# UNITED STATES PATENT AND TRADEMARK OFFICE

APPLICATION NO.	FILING DATE	FIRST NAMED INVENTOR	ATTORNEY DOCKET NO.	CONFIRMATION NO.
08/736,896	10/25/1996	CHRISTOPHER G.M. KEN	290252016600	4538

<b>Office Action Summary</b>	<b>Application No.</b>	<b>Applicant(s)</b>	
	08/736,896	KEN ET AL.	
	<b>Examiner</b>	<b>Art Unit</b>	
	Vy Q. Bui	3731

## DETAILED ACTION

FIG. 2

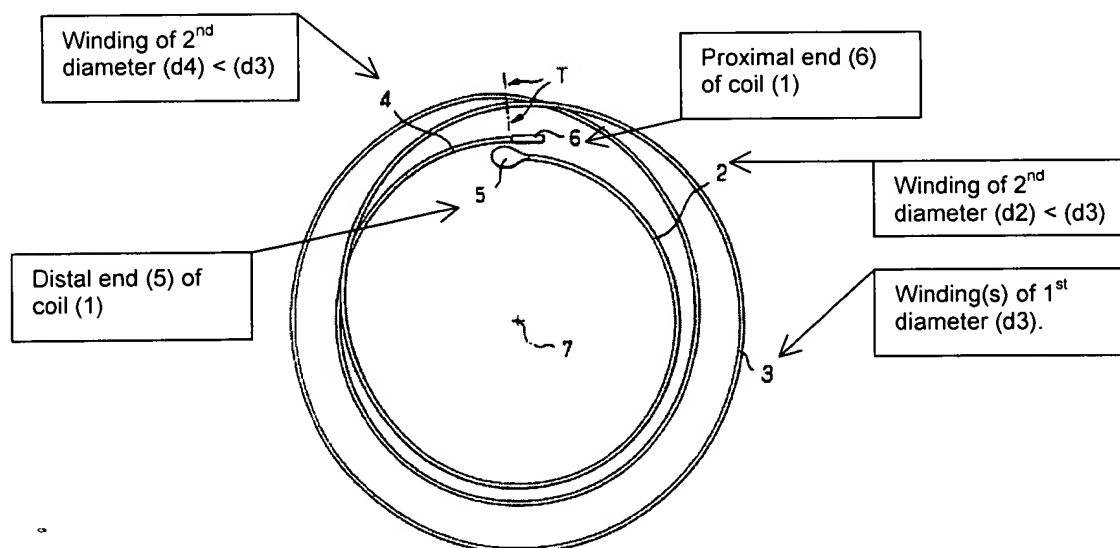
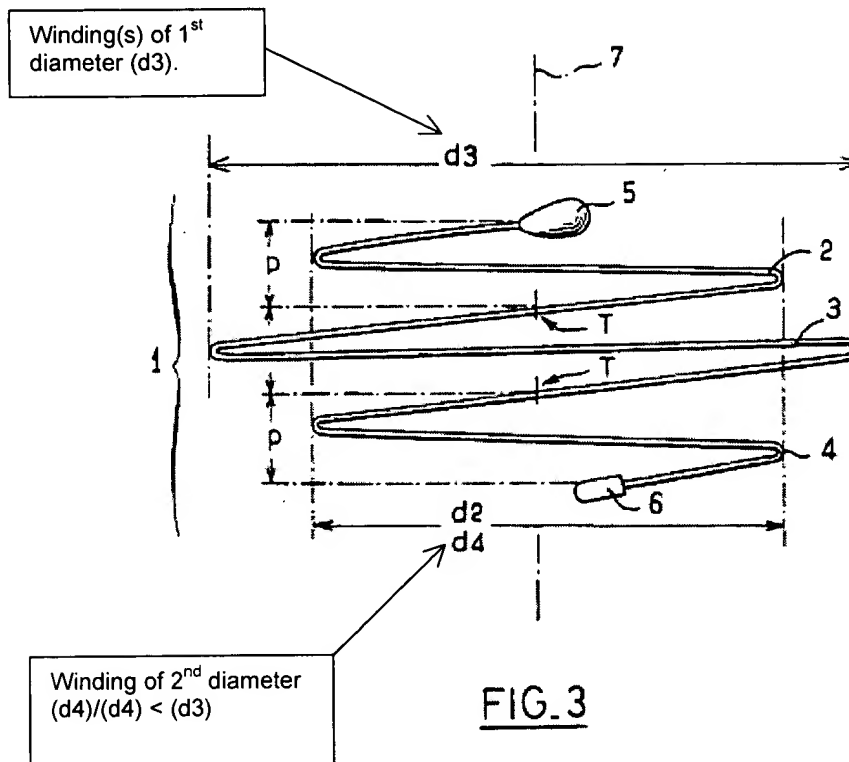
As to claims 1, 3-4, 6-10, and 12-15 DIBIE (Figs. 1-3, 5-6 and 9; column 8, lines 25-28) discloses a flexible helical coil (1) for use with a wire/cable (19). The coil has a distal end (5) and a proximal end/a second coupling member (6) detachably coupled/interlocked to the distal end/the 1<sup>st</sup> coupling member (18) of wire/cable (19) (Fig. 9). The coil comprises one winding (3) (shown in Figs. 2-3) or a multiplicity of windings (3) (not shown, but DIBIE discloses in column 8, lines 25-28 that the device can have a number of windings of more or less than three windings) of a 1<sup>st</sup> diameter (d3) immediately adjacent of the distal end (5) and the proximal end (6) of the coil. The coil further is wound into a 2<sup>nd</sup> diameter (d2)/(d4) smaller than the 1<sup>st</sup> diameter (d3) of about 27mm (column 7, lines 14-15 and Fig. 3), whereby the proximal end (6)/the 1<sup>st</sup> coupling member and the distal end (5) of the coil are positioned radially inwardly of the immediately adjacent 1<sup>st</sup> diameter (d3) as shown in Fig. 2.

Alternatively, DIBIE does not explicitly show a multiplicity of windings (3) of the 1<sup>st</sup> diameter (d3) in the drawings, however, according to the disclosure (column 8, lines 25-28), it would have been obvious to one of ordinary skill in the art to have a multiplicity of windings (3) such as two or three windings (3) as this configuration would be well within the scope of DIBIE's invention.
